# **ANCLOTE HARBOR**

## **#20-106 [PRELIMINARY PLANNED DEVELOPMENT]**

Board of Commissioners, December 8, 2020 (1st Reading)

**CITY OF TARPON SPRINGS**  
**PLANNING & ZONING BOARD / BOARD OF COMMISSIONERS**  
**November 16, 2020 / December 8, 2020 & December 15, 2020**

Figure 2  
Project Traffic Distribution  
Ancote Harbor Development  
Tarpon Springs, Florida

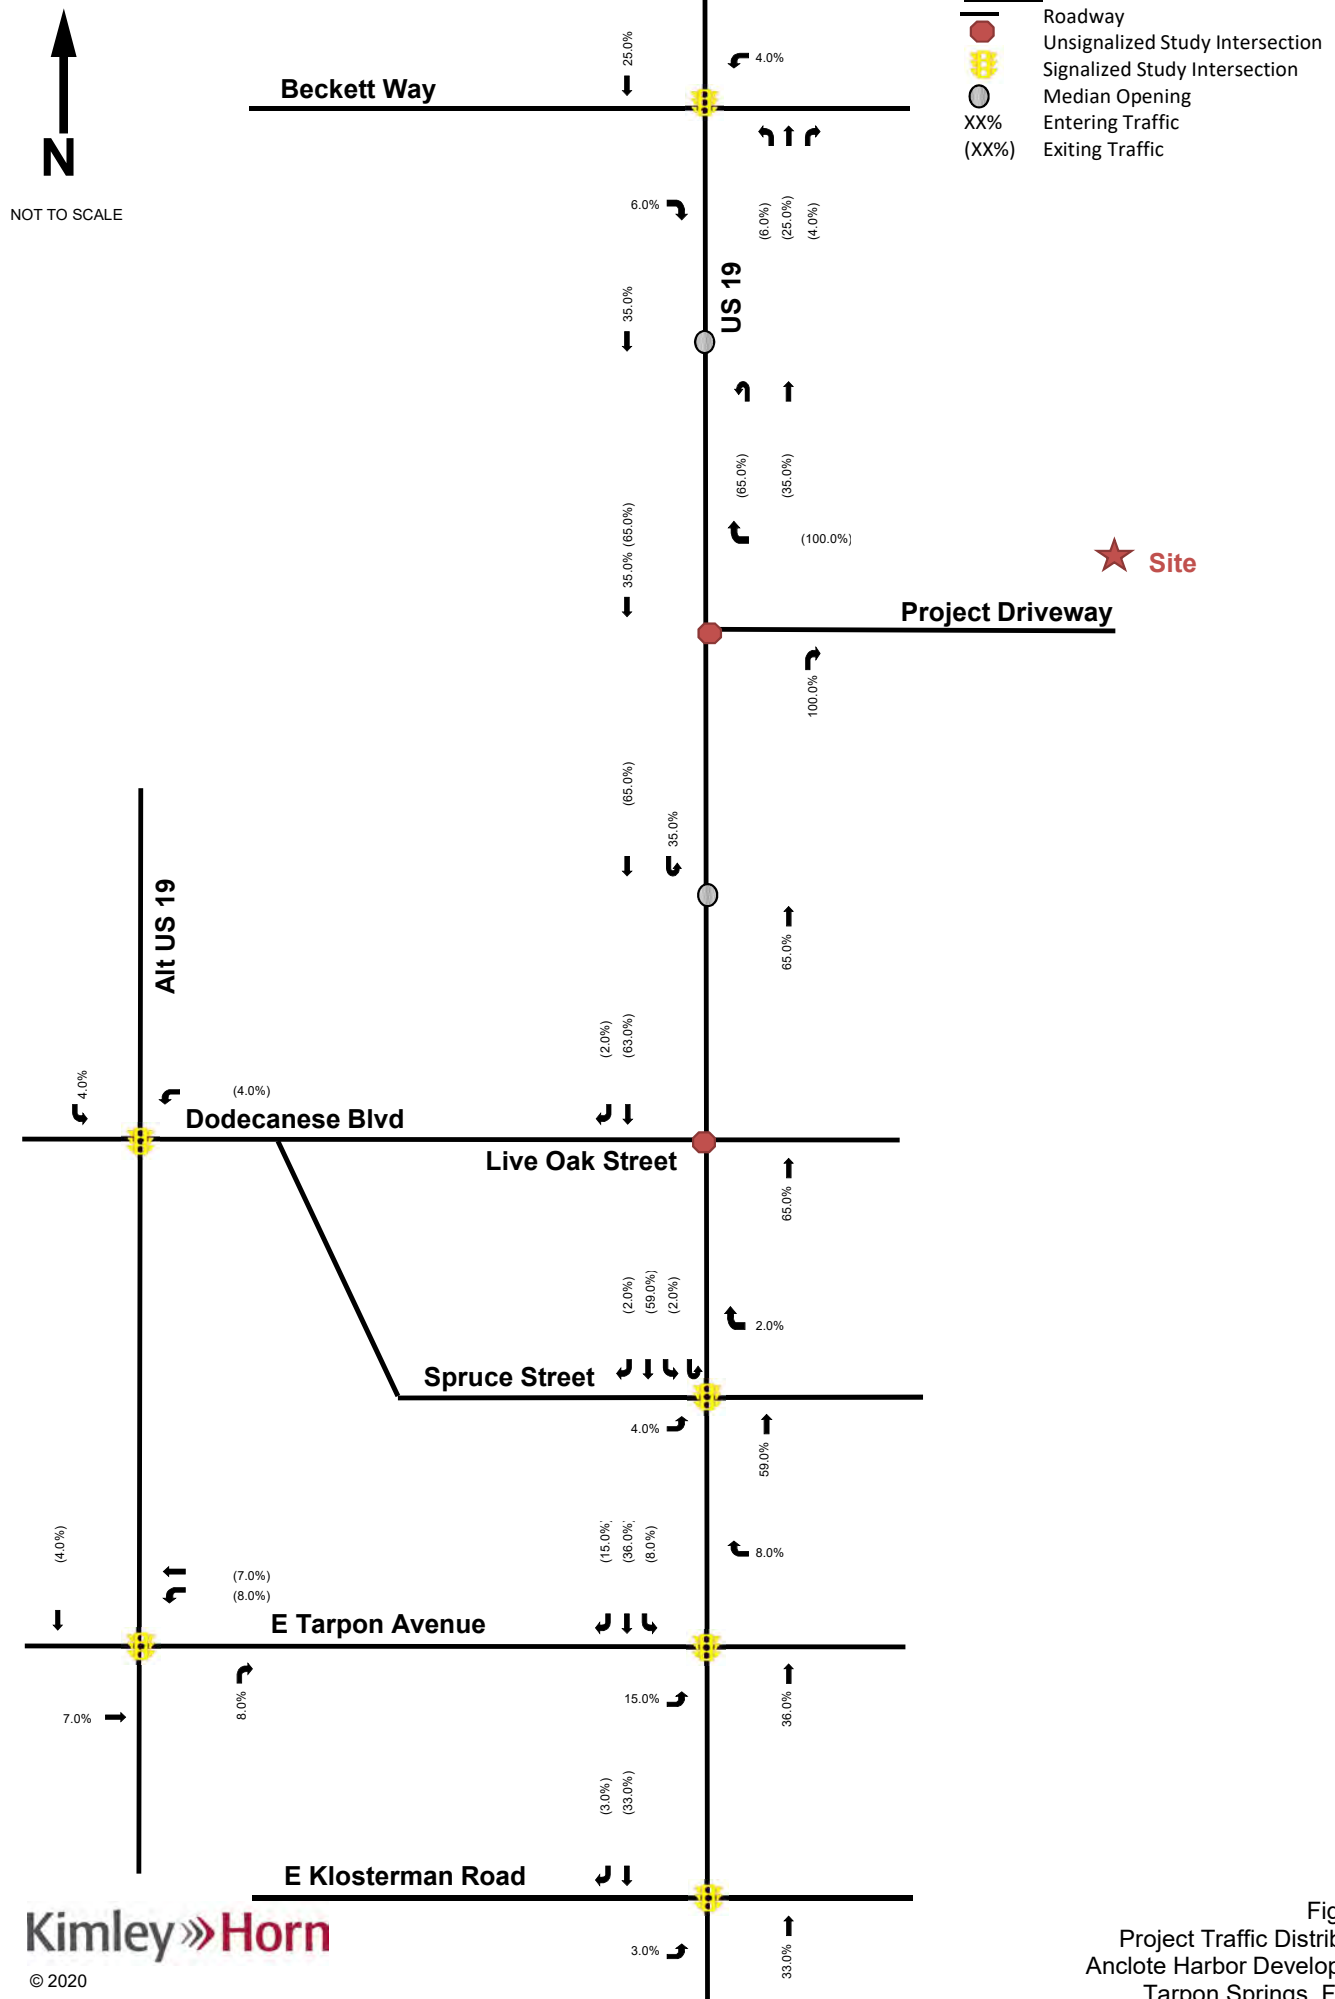
**Comment 5:** Comments on Figure 2,

Comment 5: Comments on Figure 2,

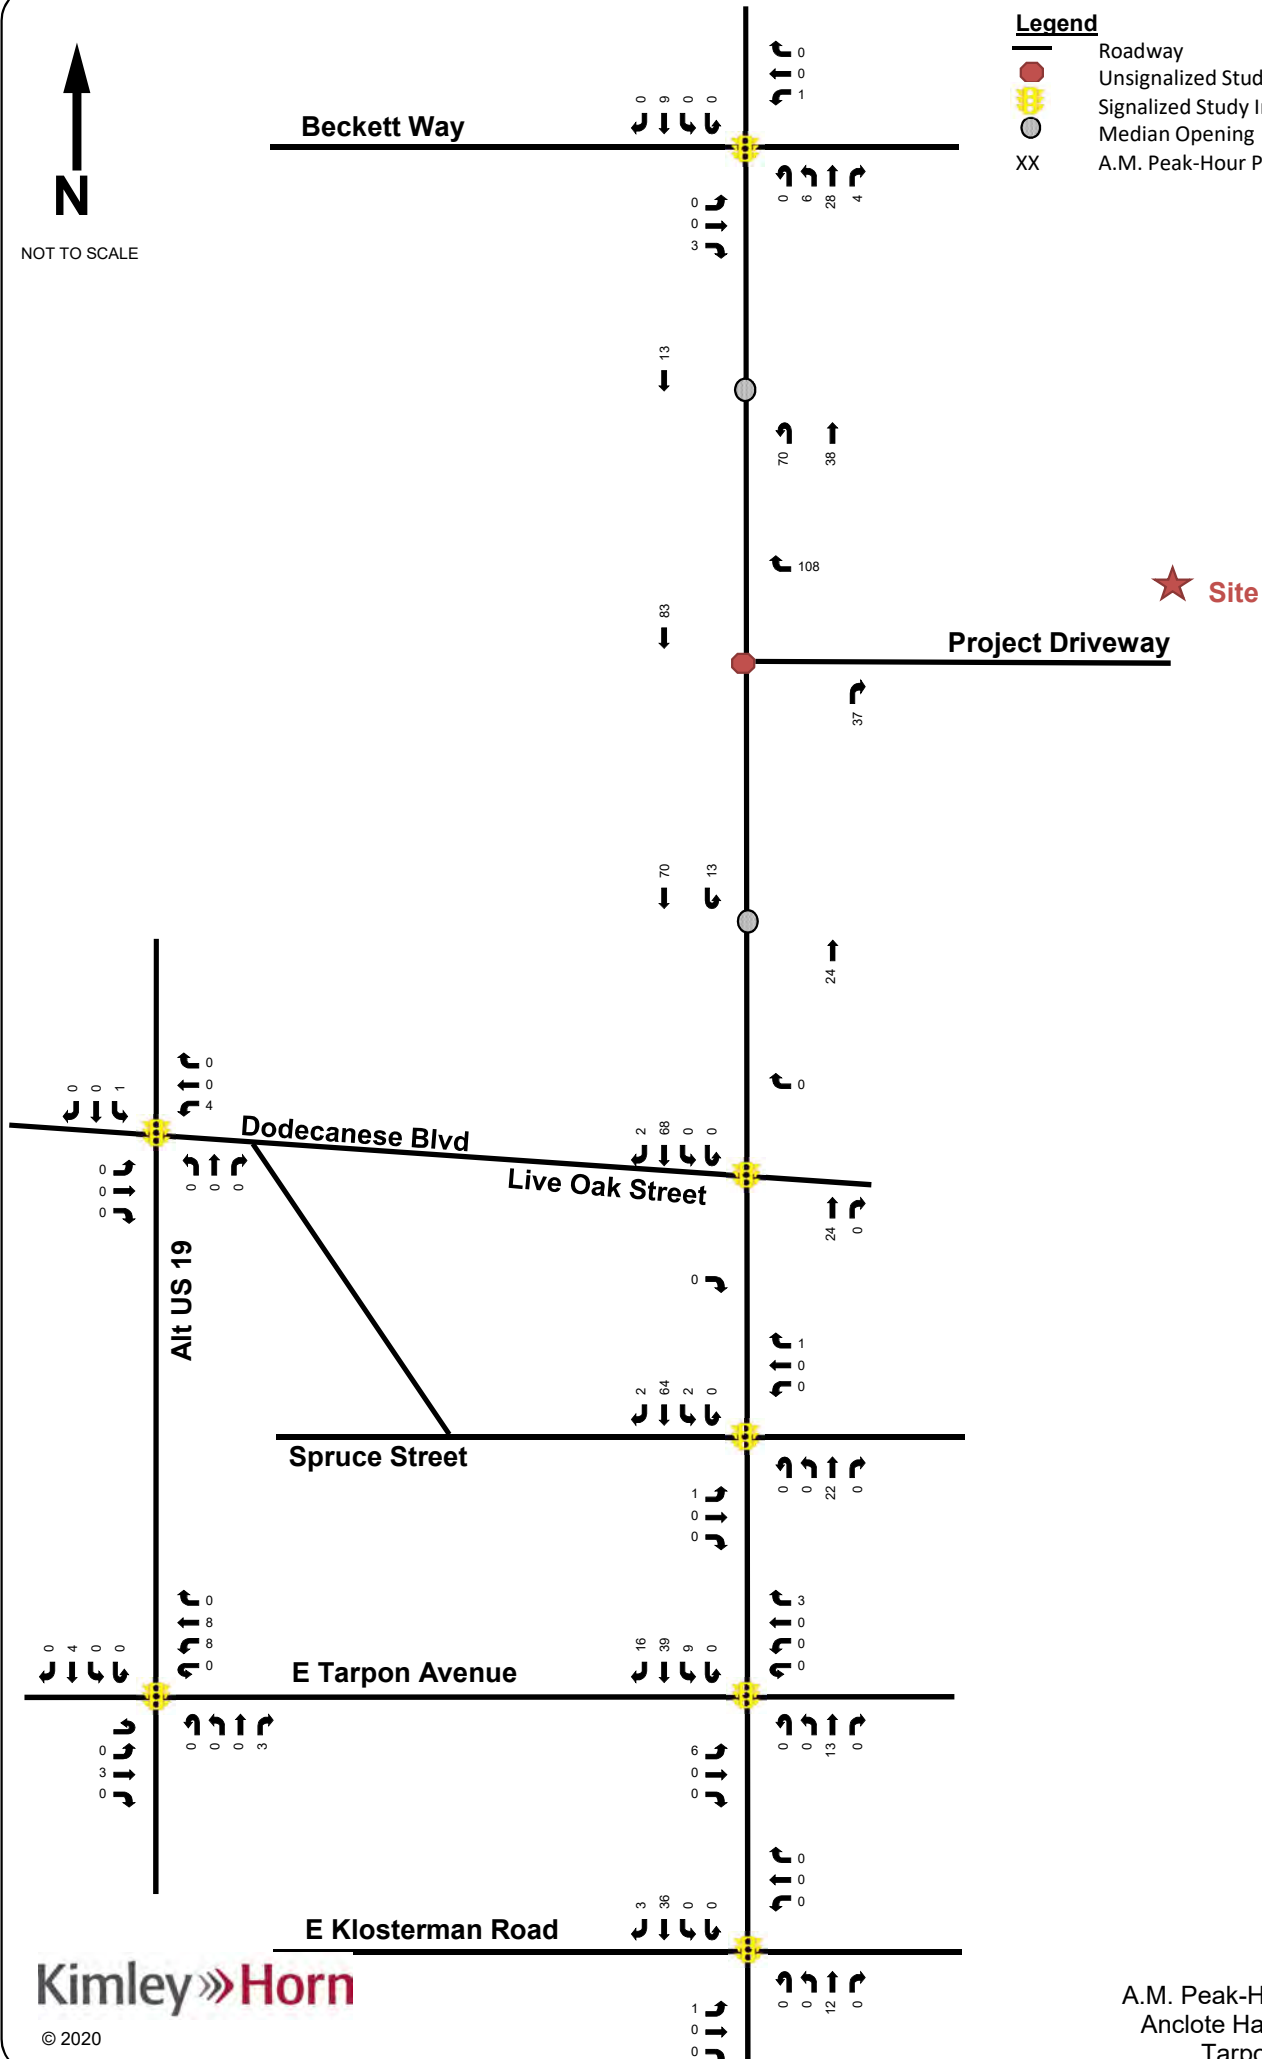
**Comment 6:** Comments on Figure 3,

- a. Traffic volumes from Beckett Way/US 19 Intersection add up to 12 vehicles for SB direction. Figure 3 shows 13 vehicles. Please confirm.
- b. Traffic volumes from Beckett Way/US 19 Intersection add up to 37 vehicles for NB direction. Figure 3 shows 38 vehicles. Please confirm.
- c. See Traffic Distribution Percentages comments from Figure 2, which would affect Figure 3.

Comment 6: Comments on Figure 3,

- a. Traffic volumes from Beckett Way/US 19 Intersection add up to 12 vehicles for SB direction. Figure 3 shows 13 vehicles. Please confirm.
- b. Traffic volumes from Beckett Way/US 19 Intersection add up to 37 vehicles for NB direction. Figure 3 shows 38 vehicles. Please confirm.
- c. See Traffic Distribution Percentages comments from Figure 2, which would affect Figure 3.

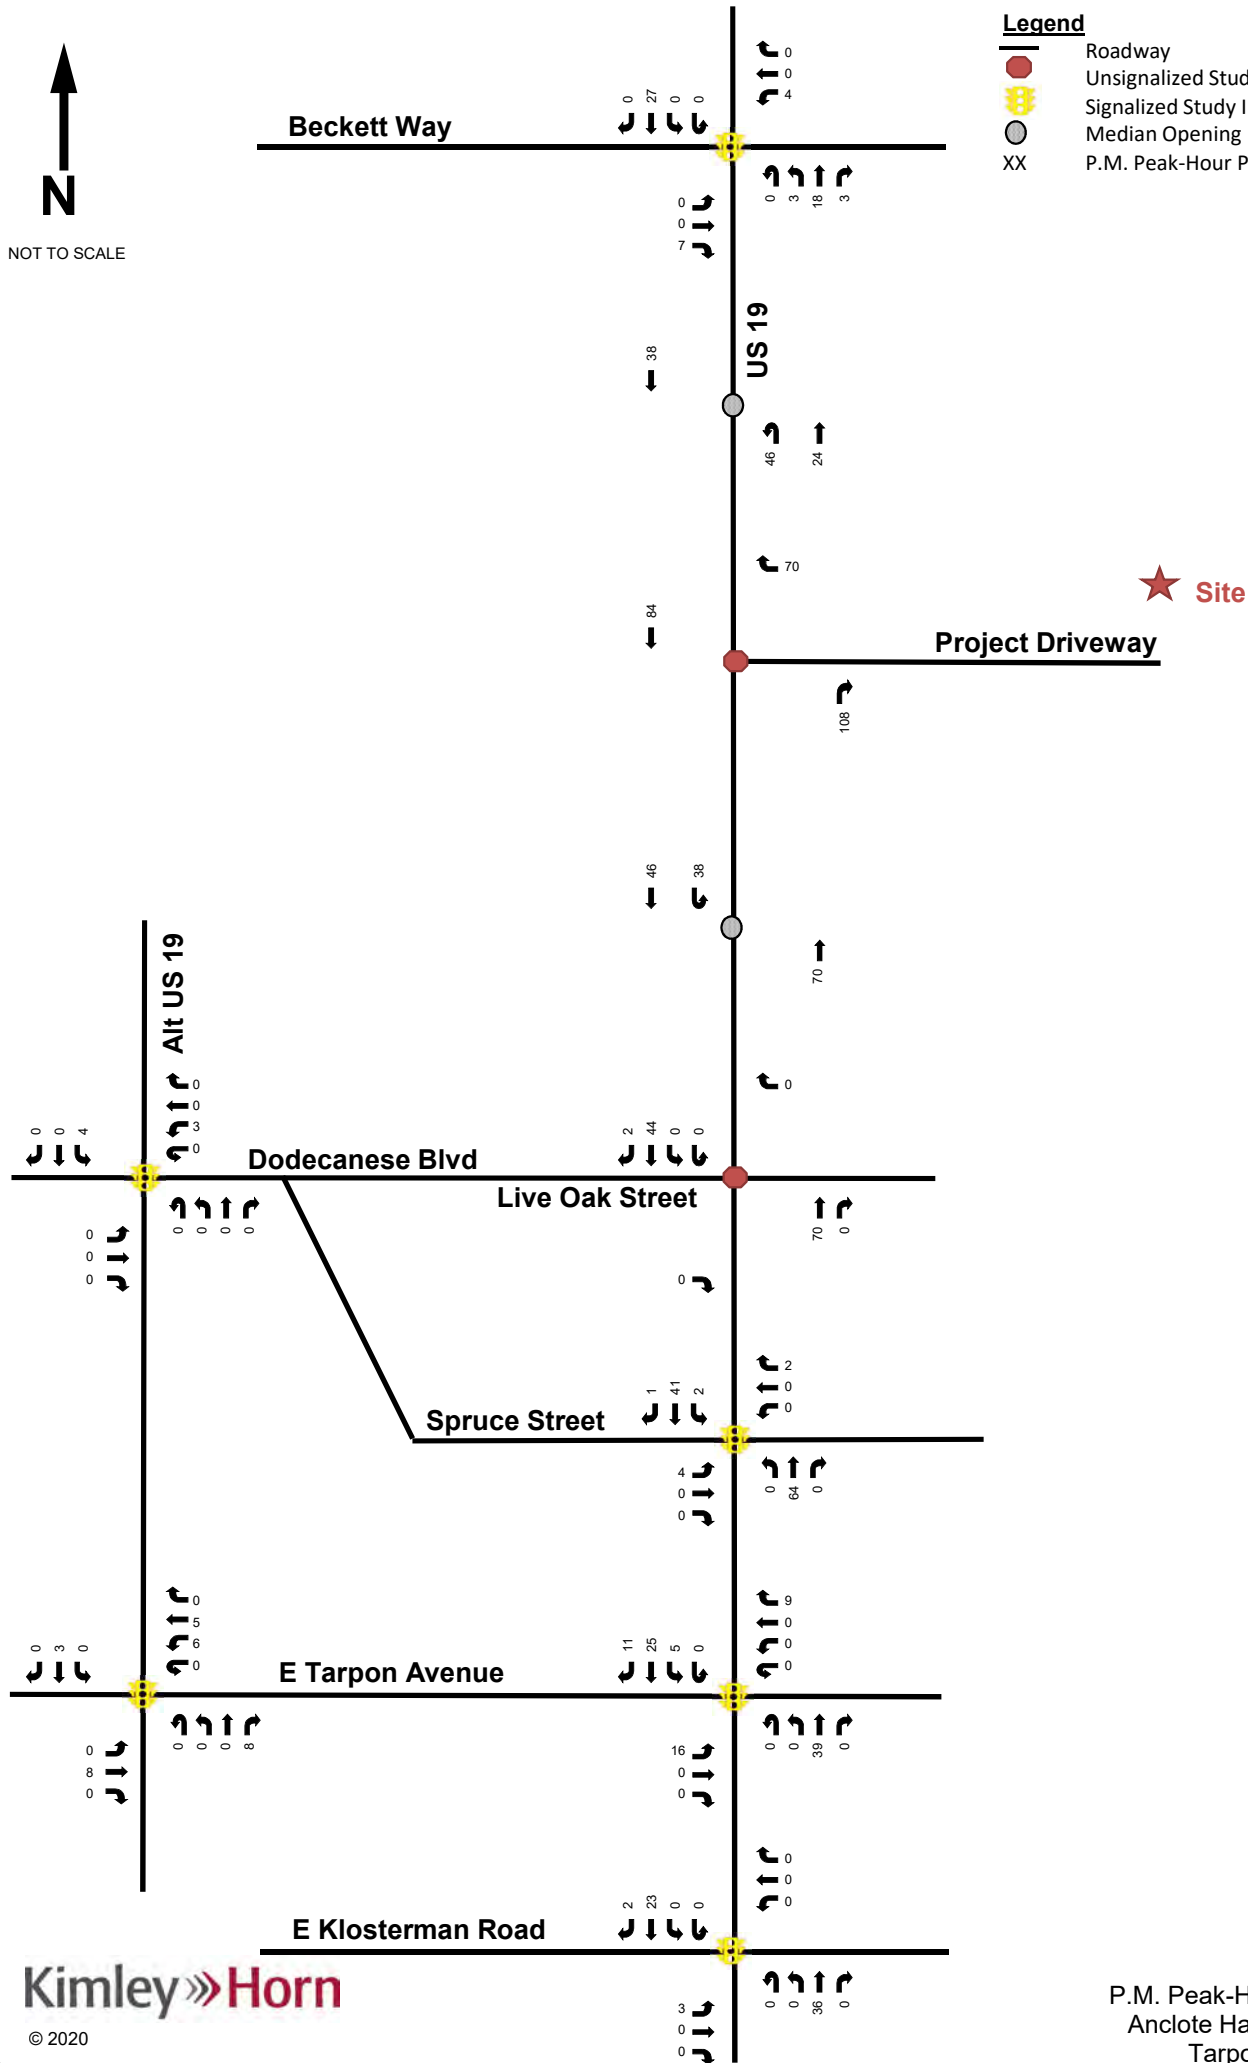
**Comment 7:** Comments on Figure 4,

- a. Traffic volumes from Beckett Way/US 19 Intersection add up to 37 vehicles for SB direction. Figure 4 shows 38 vehicles. Please confirm.
- b. The traffic volumes do not add up the driveway volumes which is 70 vehicles. Please confirm.
- c. Traffic volumes for SB approach at Live Oak St/US 19 Intersection show 45 vehicles for SB direction, whereas upstream it is 46 vehicles per Figure 4. Please confirm.
- d. See previous comment on Traffic Distribution Figure. The traffic assignment on Figure 4, at the Live Oak St/Dodecanese Blvd does not add up at the adjacent intersections of Live Oak St/US 19 and Spruce St/US 19. Also there is traffic volumes along N-S Direction, where are they leading to? Please confirm.

- e. Traffic volumes for SB approach at Live Oak St/US 19 Intersection show 44 vehicles for SB direction, whereas downstream at Spruce St., it is 45 vehicles per Figure 4. Please confirm.
- f. Traffic volumes for SB approach at Spruce St/US 19 Intersection show 41 vehicles for SB direction, whereas downstream at E Tarpon Ave., it is 42 vehicles per Figure 4. Please confirm.

Comment 7: Comments on Figure 4,

- a. Traffic volumes from Beckett Way/US 19 Intersection add up to 37 vehicles for SB direction. Figure 4 shows 38 vehicles. Please confirm.
- b. The traffic volumes do not add up the driveway volumes which is 70 vehicles. Please confirm.

- c. Traffic volumes for SB approach at Live Oak St/US 19 Intersection show 45 vehicles for SB direction, whereas upstream it is 46 vehicles per Figure 4. Please confirm.

- d. See previous comment on Traffic Distribution Figure. The traffic assignment on Figure 4, at the Live Oak St/Dodecanese Blvd does not add up at the adjacent intersections of Live Oak St/US 19 and Spruce St/US 19. Also there is traffic volumes along N-S Direction, where are they leading to? Please confirm.

- e. Traffic volumes for SB approach at Live Oak St/US 19 Intersection show 44 vehicles for SB direction, whereas downstream at Spruce St., it is 45 vehicles per Figure 4. Please confirm.

- f. Traffic volumes for SB approach at Spruce St/US 19 Intersection show 41 vehicles for SB direction, whereas downstream at E Tarpon Ave., it is 42 vehicles per Figure 4. Please confirm.
